HISTORIC AND DESIGN REVIEW COMMISSION

HDRC CASE NO: 2019-690
COMMON NAME: La Villita
ADDRESS: 423 S ALAMO ST
LEGAL DESCRIPTION: NCB 155 BLK 4 LOT 10 & E IRR 240.51 FT OF 4 & 5
ZONING: D, H, RIO-3
CITY COUNCIL DIST.: 1
DISTRICT: La Villita Historic District
LANDMARK: German-English School
APPLICANT: James McKnight/Brown & Ortiz, P.C.
OWNER: HH SAN ANTONIO LLC
TYPE OF WORK: Construction of a 9-story hotel tower, site work
APPLICATION RECEIVED: November 08, 2019
60-DAY REVIEW: January 07, 2019
CASE MANAGER: Edward Hall
REQUEST:

The applicant is requesting conceptual approval to:

SITE PLAN
Scale 1:400

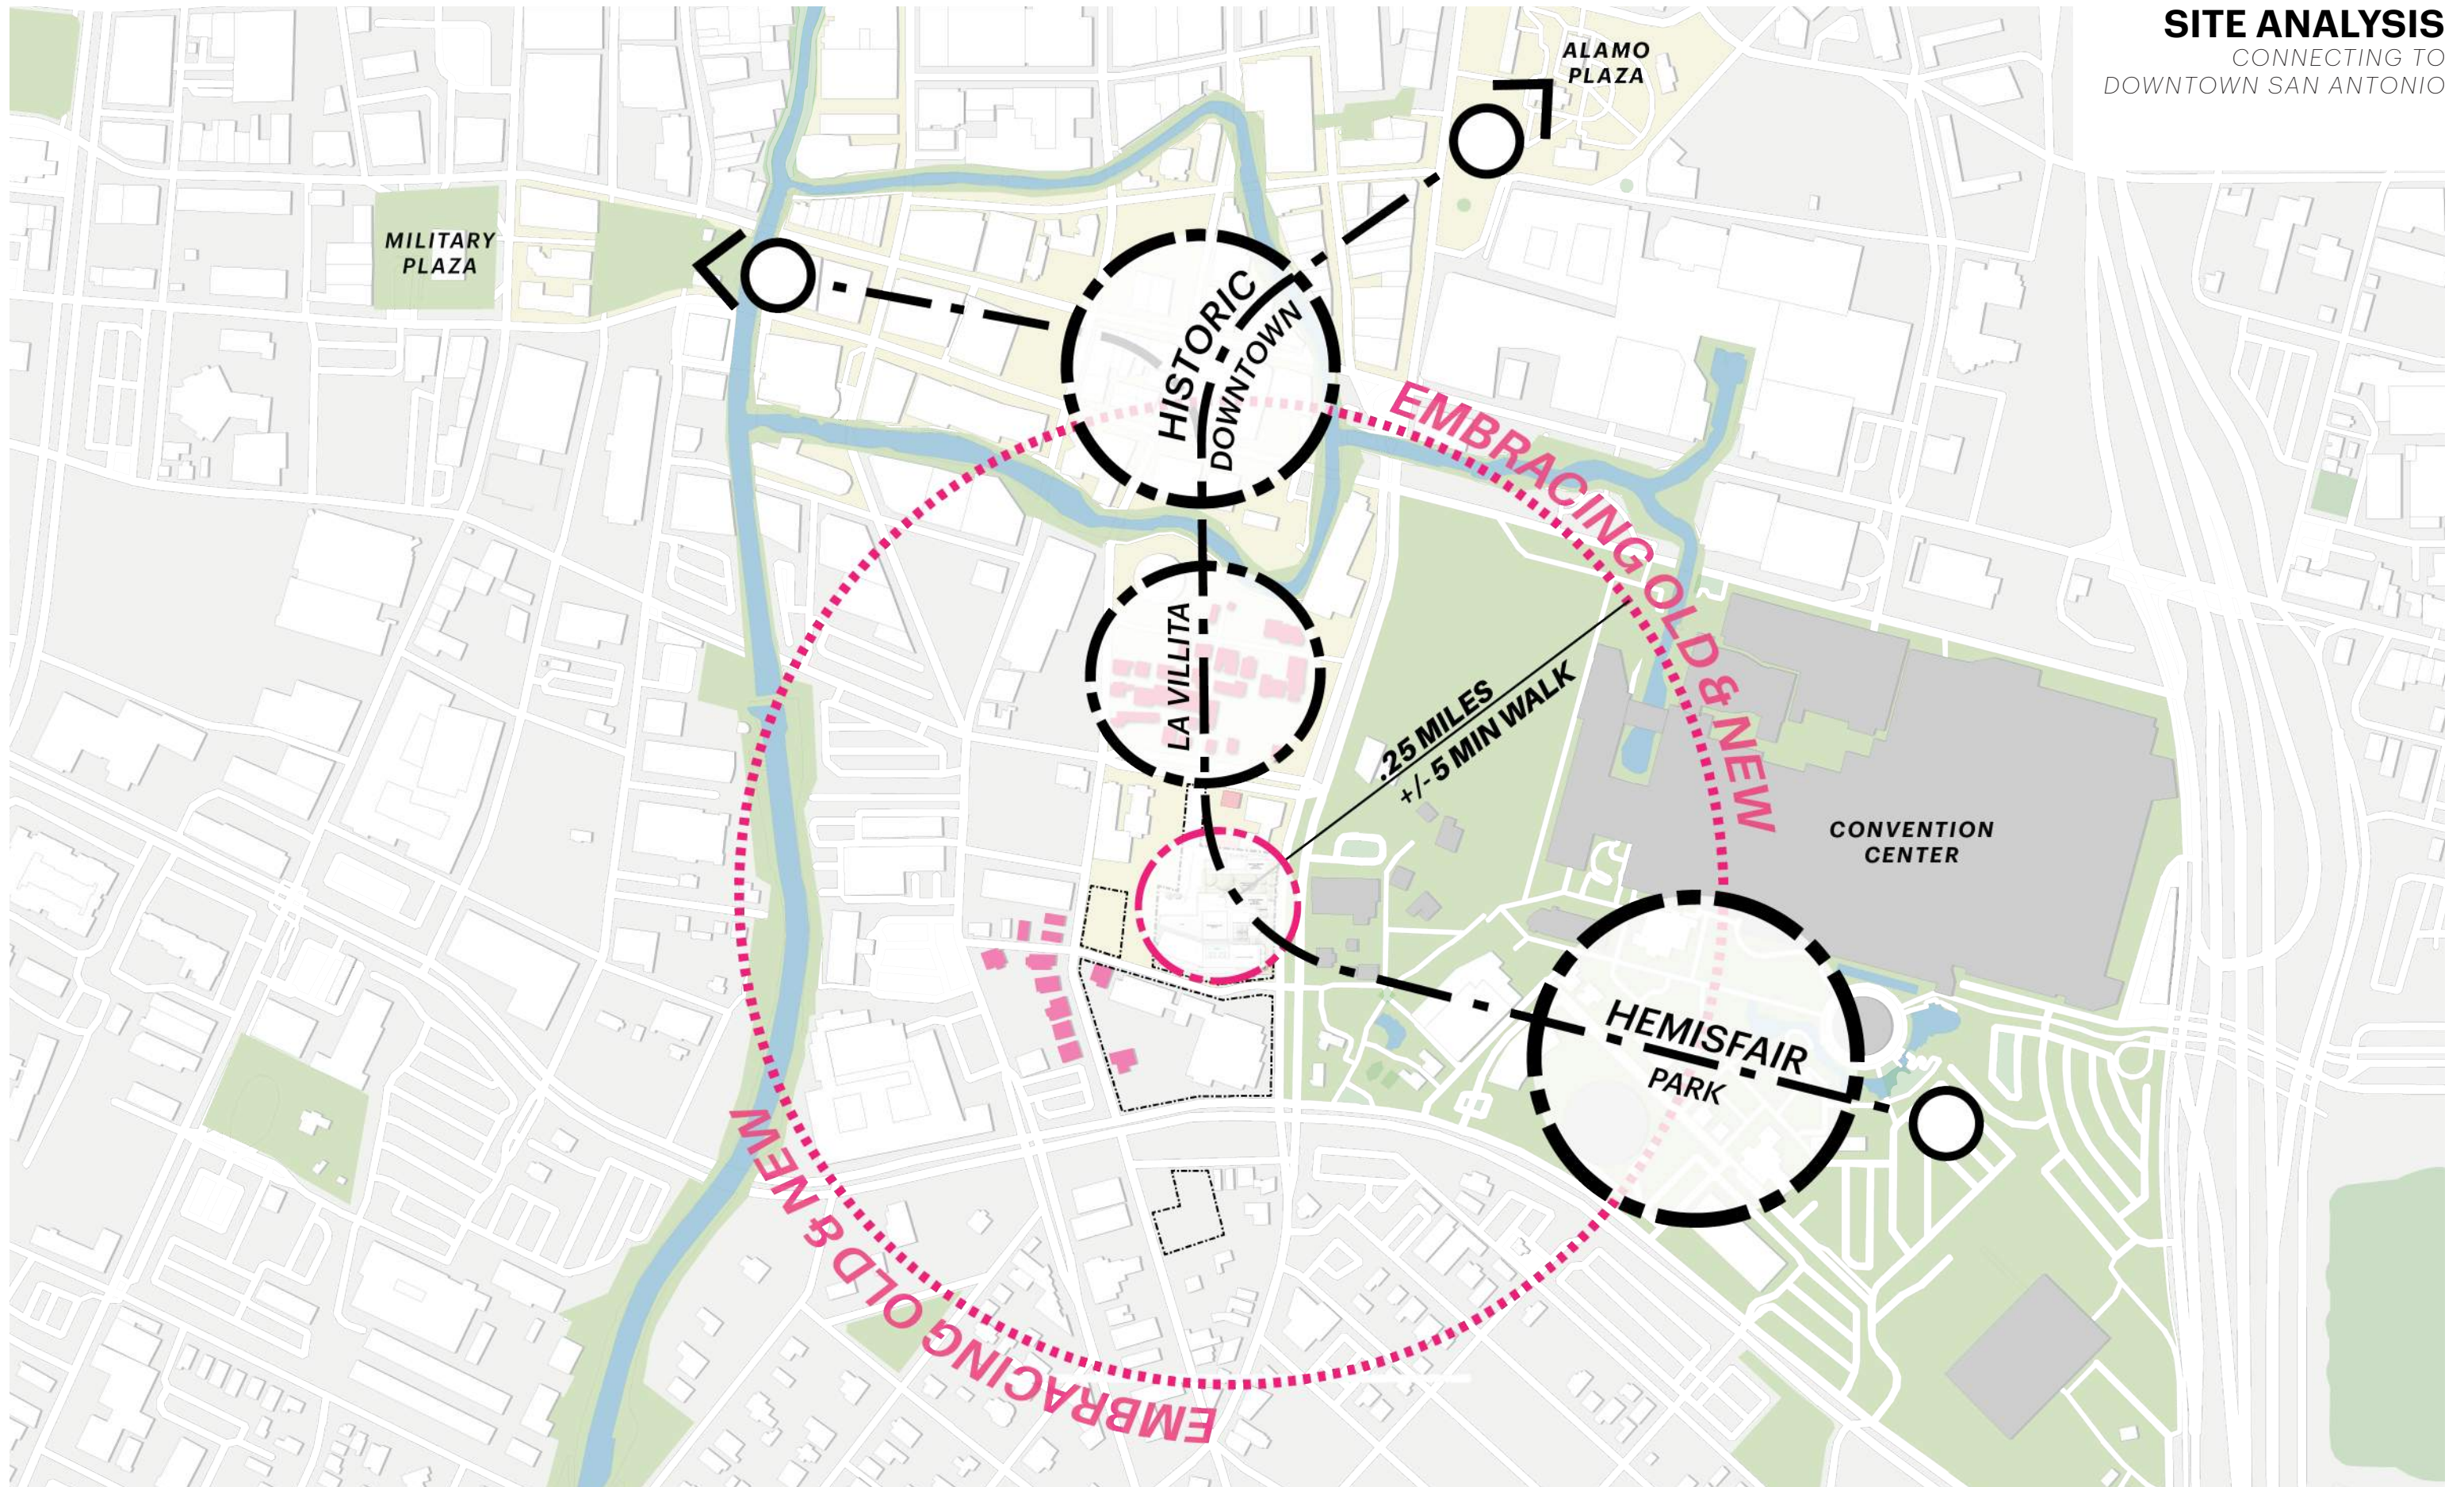
- 2c. SETBACKS & ORIENTATION – According to the Guidelines for New Construction, the front facades of new buildings are to align with front facades of adjacent buildings where a consistent setback has been established along the street frontage. Additionally, the orientation of new construction should be consistent with the historic examples found on the block. Per the submitted site plan, the applicant has proposed for the new construction to feature setbacks that are greater than and subordinate to those of the historic structures on the site, with the exception of the proposed hotel entry and drop off structure’s canopy. Staff finds that all elements of the proposed new construction should feature setbacks from S Alamo that are greater than those of historic structures on the lot.

- 2e. SCALE & MASSING – The Guidelines for New Construction 2.A. notes that the height and scale of new construction should not exceed that of the majority of historic buildings by more than one-story. This block of S Alamo features historic structures with one story in height, as well as those with multiple stories in height. The proposed new construction features one story in height, and an overall massing that is consistent with the Guidelines. Additionally, the applicant has proposed to for the new construction to feature various walls plans with various depths. Staff finds this appropriate as the proposed massing is separated and does not add visual mass by adding one continuous wall plane.

German School Courtyard

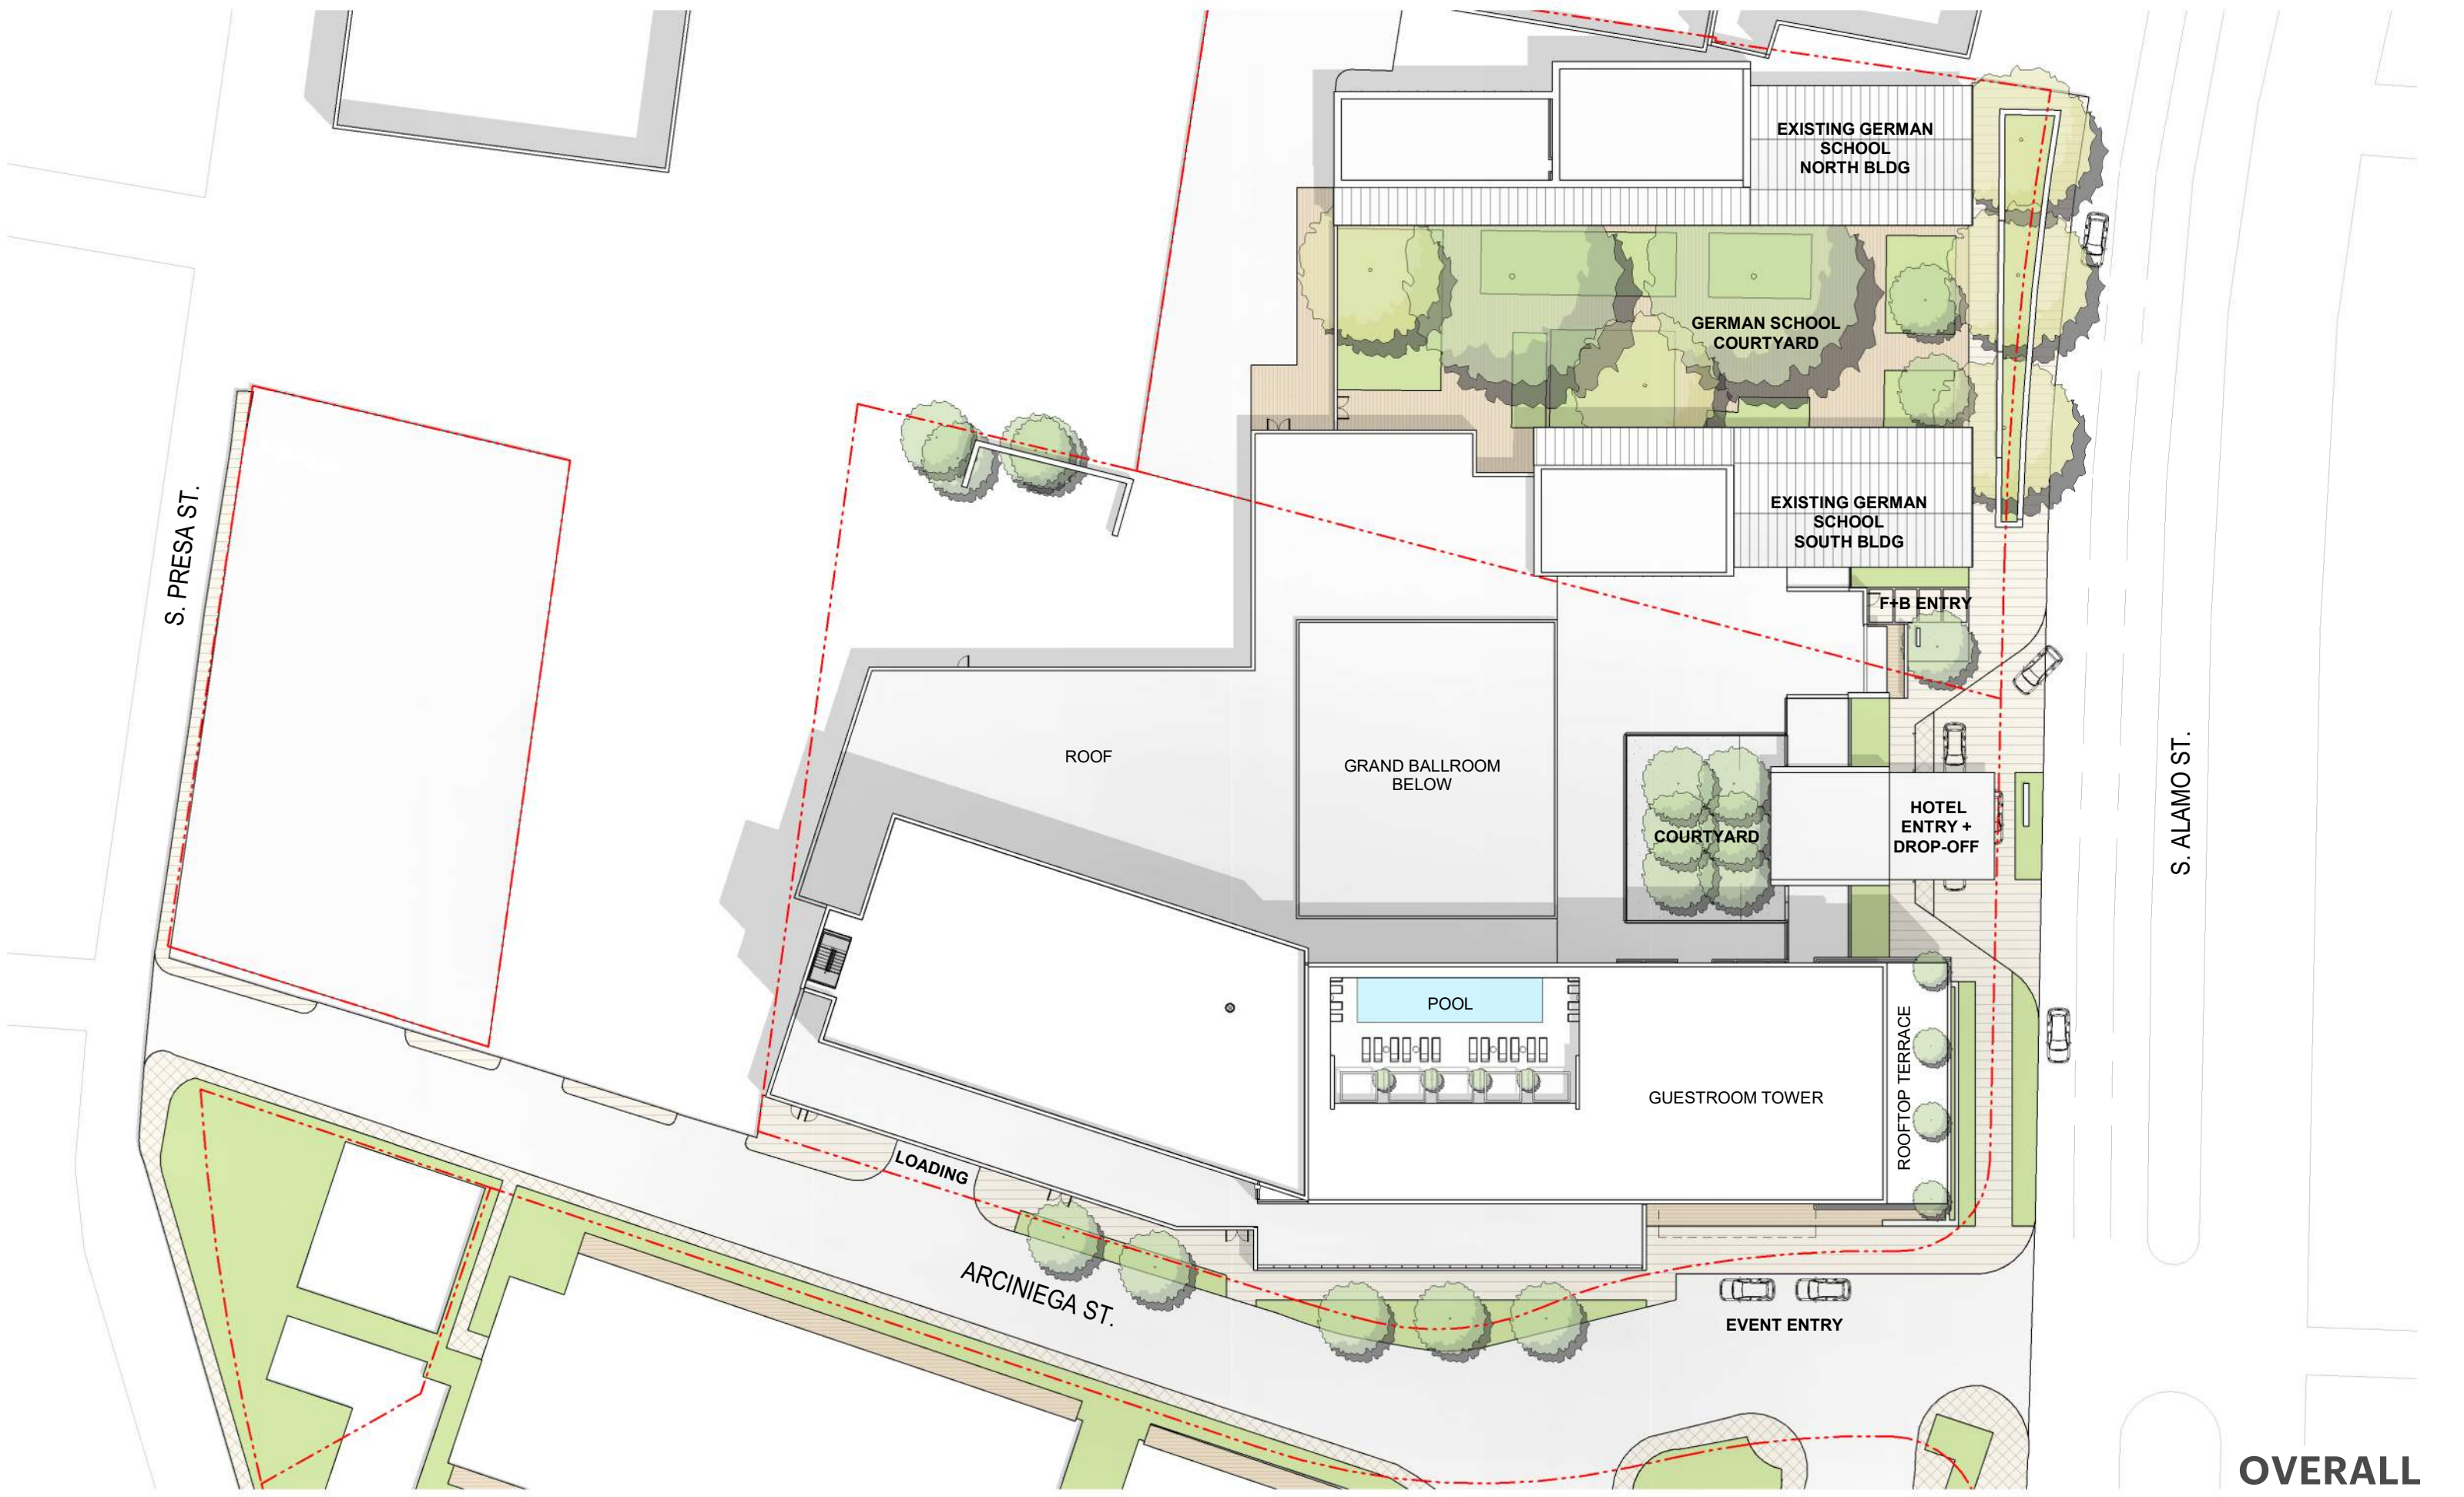
- 3a. The applicant has proposed to perform modifications to the existing courtyard between the two historic German School buildings. Currently, this courtyard features raised planting beds, Live Oaks, a fountain and an existing

- 3b. **COUTYARD MODIFICATIONS** – The applicant has proposed to modify the existing courtyard by constructing new planting beds, an outdoor bar area, and new outdoor seating areas. The applicant has not specifically noted which elements of the existing courtyard are to be replaced, and which are to be retained. Staff finds that any contributing or historic elements of the existing courtyard, including paving, should remain as it currently exists. Non-original elements may be removed or modified; however, these modifications should be done in a manner that does not negatively impact existing, historic elements, or result in new conditions that are incongruous with the historic spatial relationships of the site.

- 3c. **OUTDOOR FURNITURE** – The applicant has proposed outdoor seating areas in the existing courtyard. High quality street furnishings are required per UDC Section 35-673(i). The applicant is responsible for complying with this section of the UDC.

- 3d. **LANDSCAPING / SITE LIGHTING** – As noted in findings h and i, the applicant has not provided specifics for site lighting and landscaping at this time. Staff finds that a detailed site lighting and landscaping plan should be submitted when returning to the HDRC for final approval.

- ii. That the applicant continue to explore ways to utilize traditional materials, forms and details as noted in finding 2i.
3. Staff recommends approval of item #3, modifications to the existing courtyard based on findings 3a through 3d with the following stipulations:

- i. That all modifications be done in a manner that does not damage historic or contributing elements, and that all historic and contributing elements remain as they currently exist.

- ii. That the applicant submit both a landscaping and site lighting plan when returning to the Commission for final approval as noted in finding 3d.
